Total water vapour columns derived from Sentinel 5p using the AMC-DOAS method, by Tobias Kuechler et al.

The paper describes the application of the existing AMC-DOAS algorithm, for the retrieval of total column water vapour, to measurements of the TROPOMI instrument on Sentinel-5P. Furthermore, an inter-comparison is carried out with other data sets.

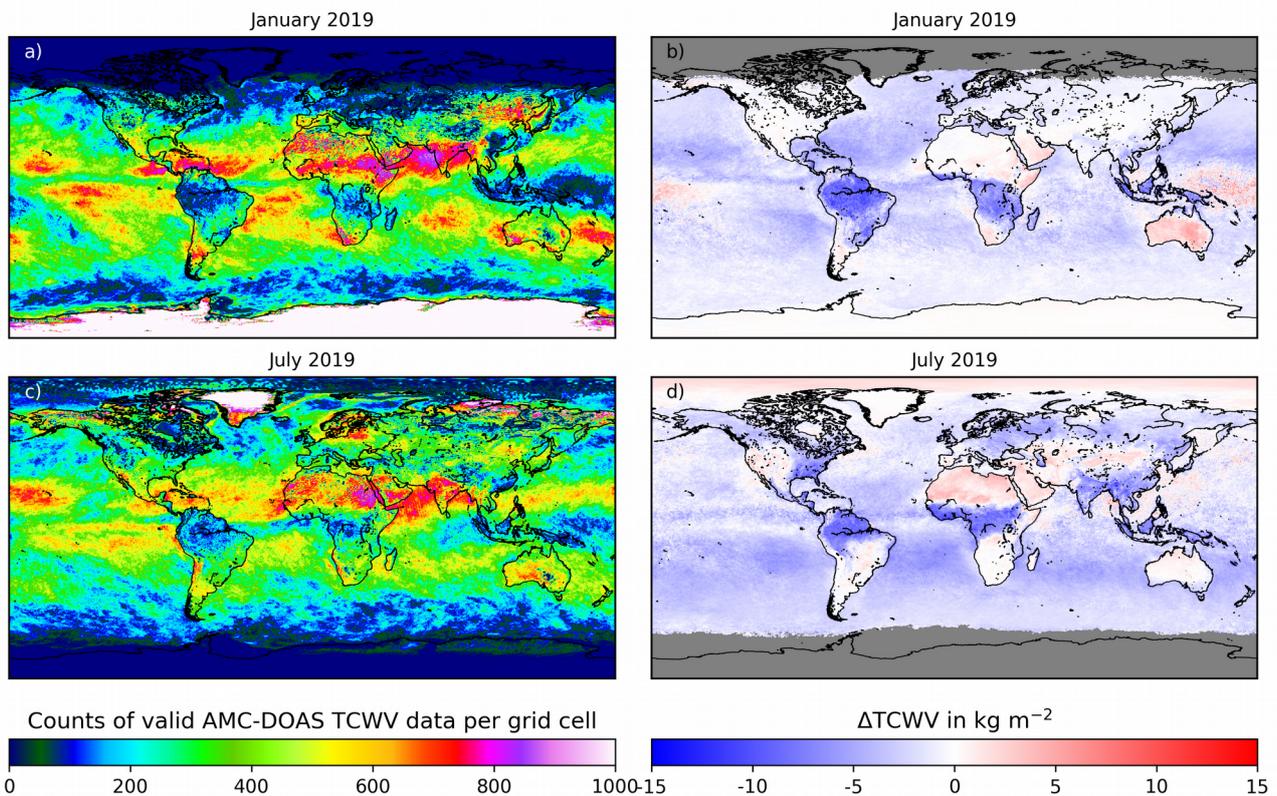
(Q18) p.24 Fig.8 Can you show the average cloud cover in this month (as proxy the number of filtered/valid observations) ? Is there a relation to negative values (e.g. in the tropical rainforest)?

(A18) The image above shows the monthly sum of the daily counted valid AMC-DOAS S5P TCWV data within one gridbox (left column). The right column shows the deviation between the

ERA5 TCWV and AMC-DOAS S5P TCWV. The counts can be used as a rough estimate of the cloud fraction filter within the tropics. Actually the negative values indeed correlate with the regions with low data availability, e.g. in the tropical rain forest. This means that probably many cloudy scenes have been filtered out. However the ERA5 data are filtered in the same way before the averaging (only collocated data are used). Therefore this should not be a sampling issue. However, this indicates that the observed differences at these regions are probably less reliable. We will mention this in the text as follows:

„The observed negative differences between ERA5 TCWV and AMC-DOAS S5P TCWV at tropical regions, e.g. tropical rain forests, correlate with regions of low data availability. We infer that these values are possibly less reliable.“
